MODIFICATION WORK ORDER

MODIFICATION OF 1-1/4 TON VEHICLES

M998 SERIES

This modification provides a retrofit to the latest configuration of power steering systems on M998 Series vehicles fielded under contract DAAE07-83-C-R034.

FIGURE 1

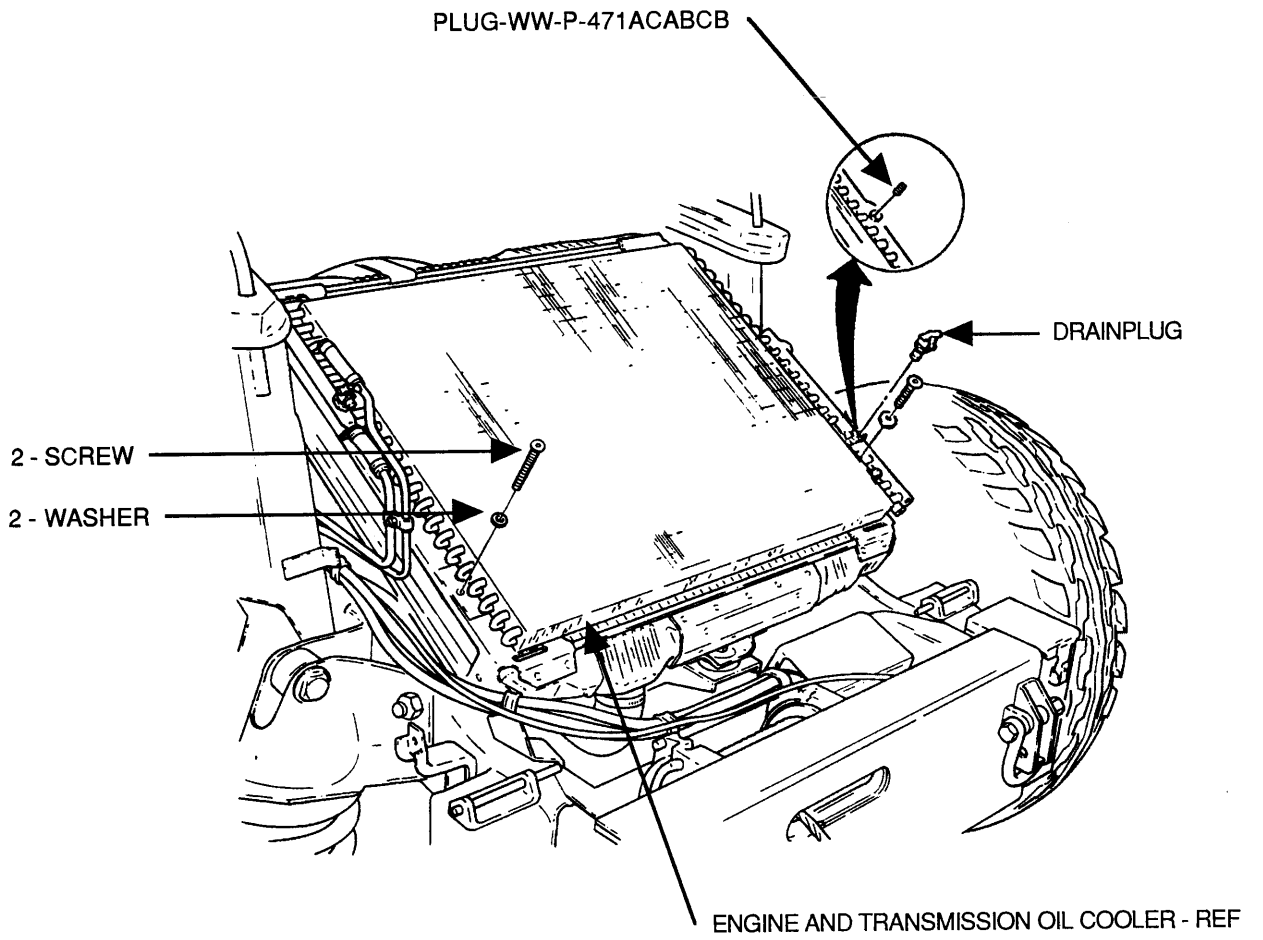
- (1) Disconnect battery ground cable. (Refer to TM 9-2320-280-20.)
- (2) Remove hood. (Refer to TM 9-2320-280-20.)
- (3) Remove left side splash shield. (Refer to TM 9-2320-280-20.)
- (4) Remove drainplug from oil cooler as shown in figure 1.

- (5) Install WW-P-471ACABCB plug in oil cooler as shown in figure 1.
- (6) Remove two lower screws and washers from oil cooler as shown in figure 1.
- (7) Remove two nuts, washers, screws, and clamps from power steering hoses as shown in figure 2. Save for installation.
- (8) Remove two clamps and hose from control valve elbow and steering gear as shown in figure 2. Save for installation.

FIGURE 3

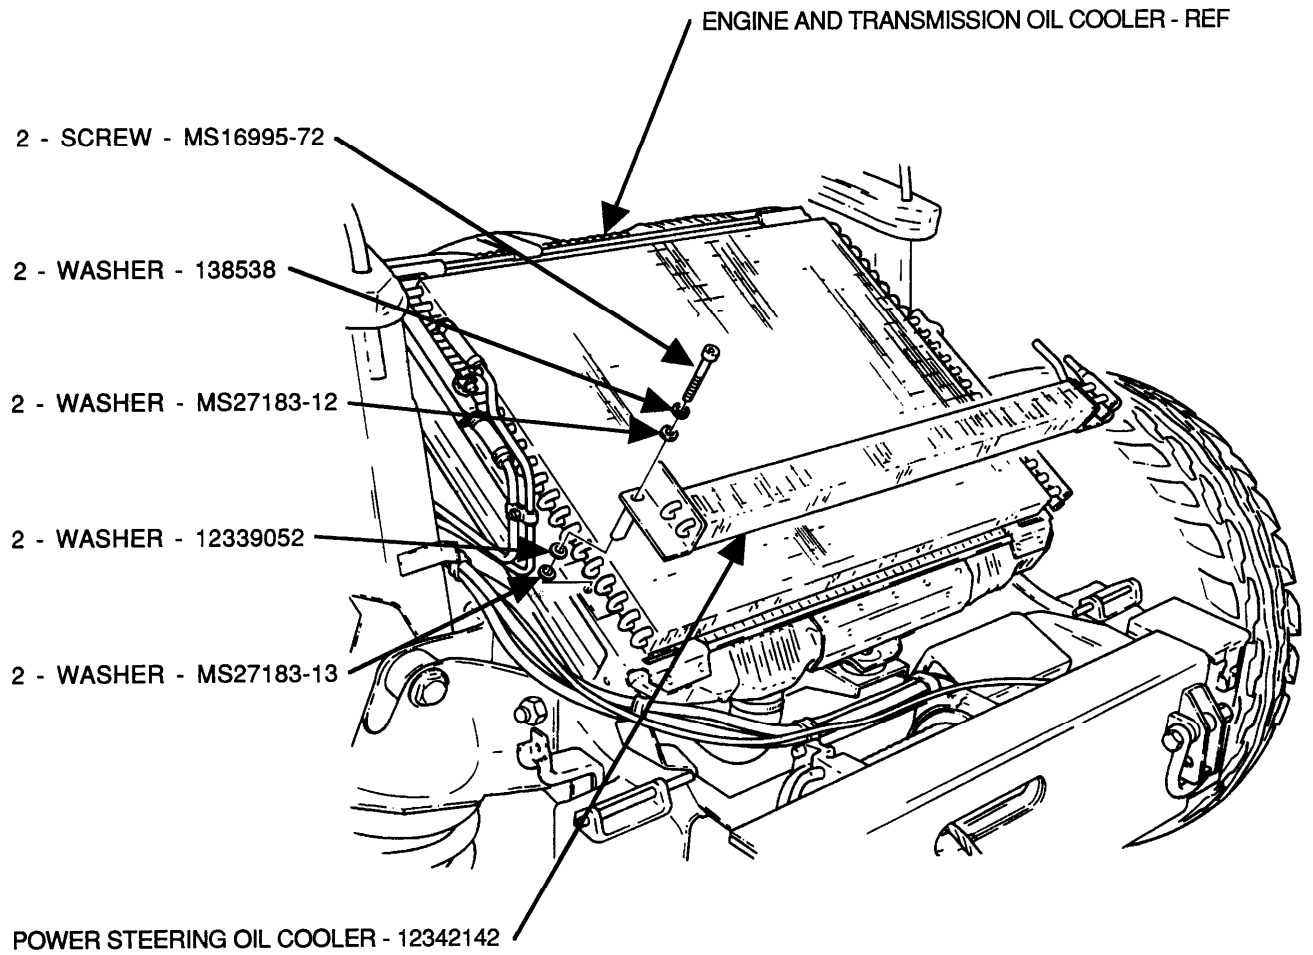
(1) Position two MS16995-72 screws, 138538 washers, and MS27183-12 washers to 12342142 power steering oil cooler as shown in figure 3.

(2) Position two 12339052 washers and MS27183-13 washers to oil cooler as shown in figure 3.

(3) Install power steering oil cooler to oil cooler and secure with two screws as shown in figure 3. Tighten screws to 12-14 lb-ft (14-18 N m).

FIGURE 4

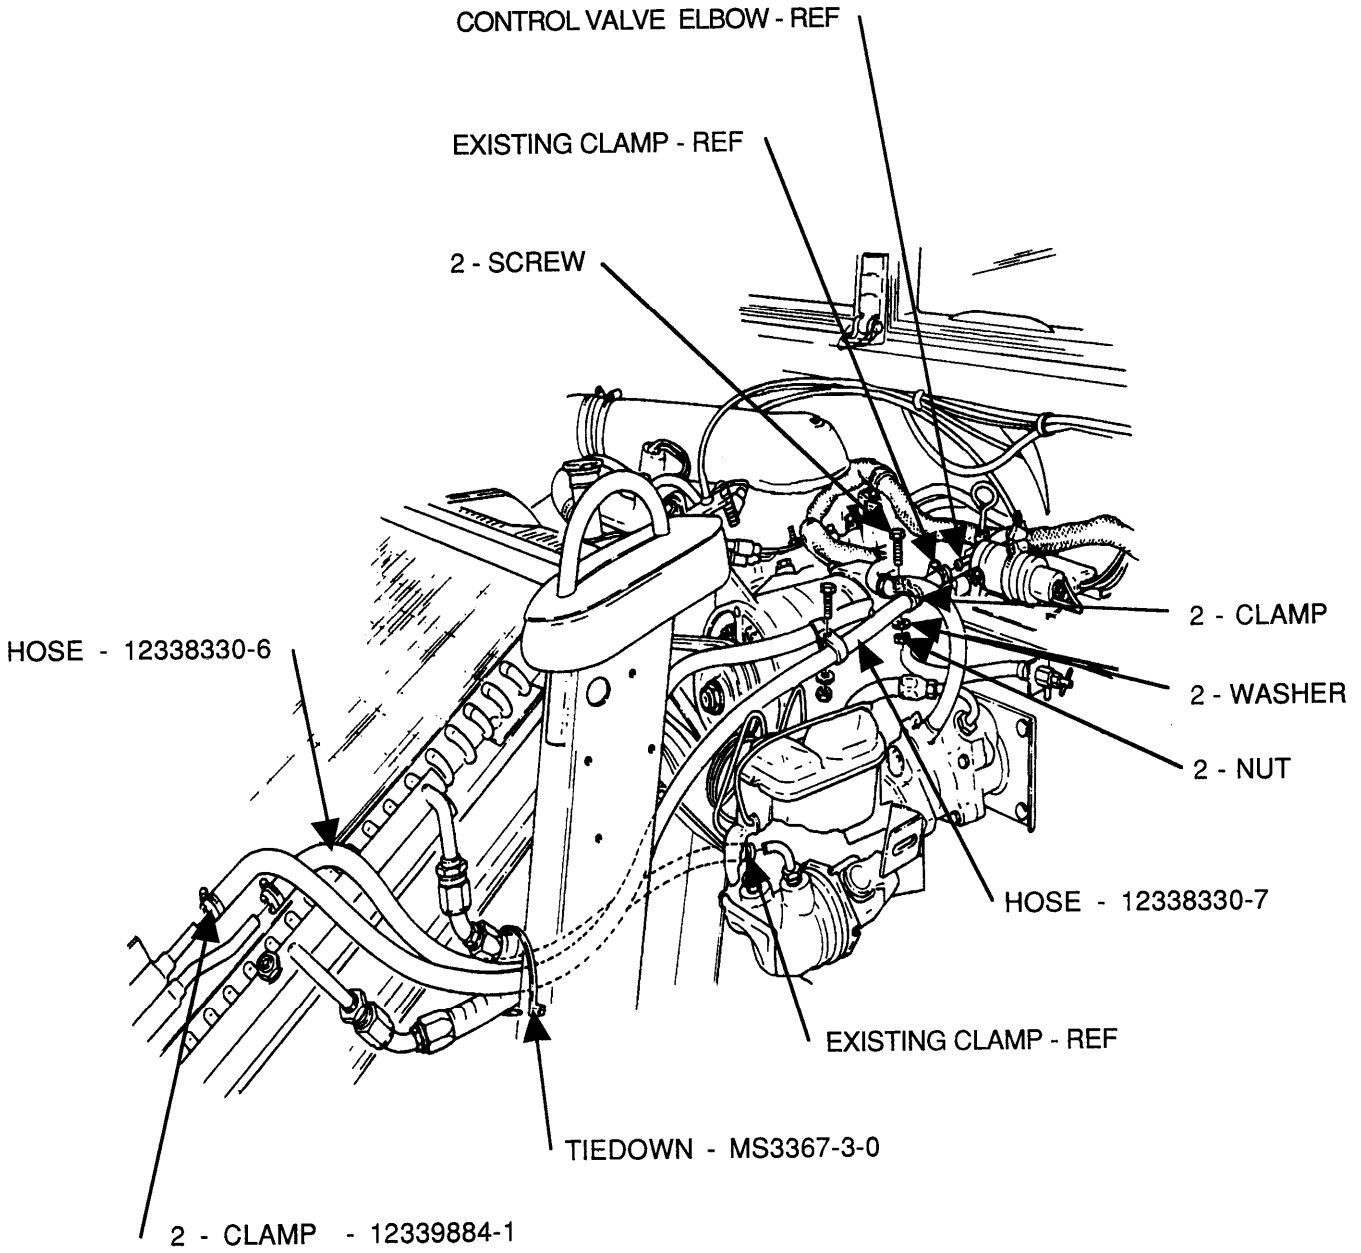
(4) Install 12338330-6 hose to power steering oil cooler and power steering gear and secure with 12339884-1 clamp and existing clamp as shown in figure 4.

(5) Install 12338330-7 hose to power steering oil cooler and control valve elbow and secure with 12339884-1 clamp and existing clamp as shown in figure 4.

(6) Position two existing clamps on hose and secure with two screws, washers, and nuts as shown in figure 4.

(7) Secure hoses with MS3367-3-0 tiedown as shown in figure 4.
